VALUE ENGINEERING CHANGE PROPOSAL
MISSOURI DEPARTMENT OF TRANSPORTATION

Contract ID 101217-503 **Job No.** J5S2179

MoDOT - RTE. 242 - MILLER/CAMDEN CO.
Conceptual VECP Proposal Submittal Data
Bloomsdale Excavating Co., Inc.
W. By-Pass Rte. MM

The contractor proposes to reconfigure the new Route MM stage 1 bypass in such a way as to eliminate the need for the stage 2 bypass.

TRAFFIC CONTROL
WEST END - STAGE 3

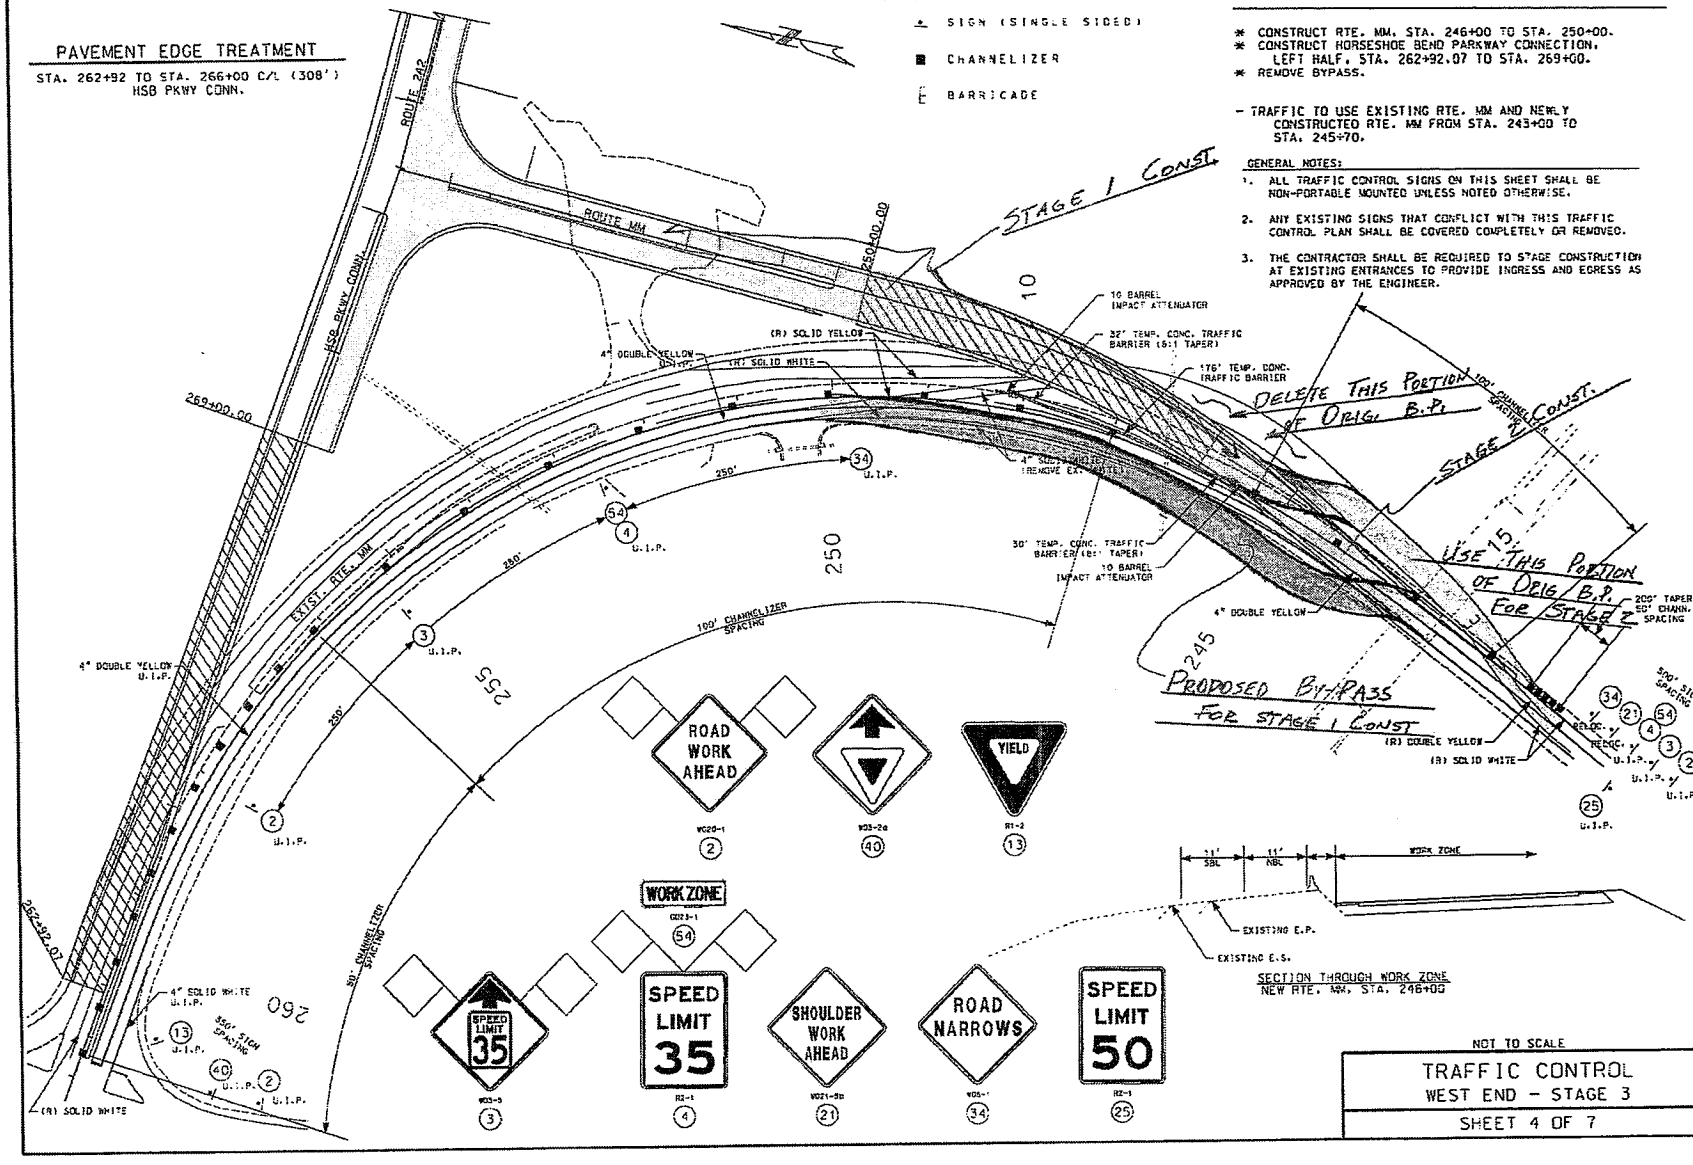
1. **Description of existing requirements and proposed change(s). Advantages/Disadvantages**
   Plans for new Rte. MM has a conflict for stage 1 sta 250+00 left slope encroaches on existing Rte. MM by approx. 50'. Another conflict for stage 2 sta 246+00 right pavement and shoulder encroaches on the by-pass by approx. 15'. Both conflicts require the Rte MM construction for stage 3 to be revised. Bloomsdale proposes to construct a new by-pass on the west side of existing Rte. MM and shortening the existing by-pass by about 275'. This new relocation would allow stage 2 construction to be eliminated.

In preparation for construction of the new Rte. MM roadway and related stage construction phases shown in the plans, we have discovered some conflicts that prevent us from constructing the roadway to the limits shown. Specifically in Stage 1, the plans indicate that Rte. MM should be constructed from the intersection with Rte. 242 south to sta. 250+00. The left slope at sta. 250+00 will extend approximately 50 ft. into the existing Rte. MM roadway. Construction cannot extend south of sta. 251+00 in order for the slope to not interfere with the existing roadway.

In Stage 2, Rte. MM is to be constructed from sta. 243+00 to sta. 246+00. A portion of the right side of the pavement and the right shoulder extend into the specified By-Pass fill. The roadway will have to be stopped short of sta. 246+00 or the By-Pass moved out to provide clearance for construction.

Bloomsdale Excavating Co., Inc. would like to propose a VECP to construct a new By-Pass on the west side of existing Rte. MM. This location would allow traffic to be switched once and the new Rte. MM could be constructed from the intersection south to sta. 244+50. Then traffic could be switched to a portion of the original By-Pass so the south tie-in to the existing pavement can be made. This proposal would delete the original stage 2 construction shown in the plans. This would eliminate one traffic lane shift resulting in less confusion and more safety for the traveling public.

I recommend approval of this Value Engineering Concept. MODOT Design has been asked to review the concept and provide the detailed design changes in order to expedite the project and prevent delays. Although there is an error in the Stage 1 Construction this V.E. Concept and calculations do not take advantage of any of these errors.

This VE proposes a very feasible and cost-effective approach to constructing stages 1, 2 + 3 on the project's west end, which otherwise would have been infeasible. Additional comments Re: this VE proposal are found in P. Lemongelli's email on 7/29/11 (attached).

that the new bypass on the west side meets appropriate design standards, including geometrics (particularly the "S" curve on the south end), typical, and temporary traffic control (speed limit, signing, temp barrier on the bypass and protection of the bridge pier). Our design staff is willing to work on plan sheets for the typical, profile, alignment, x-sections, and determine temp traffic control, including whether we need temp barrier on both sides of the bypass, which could add to the savings.
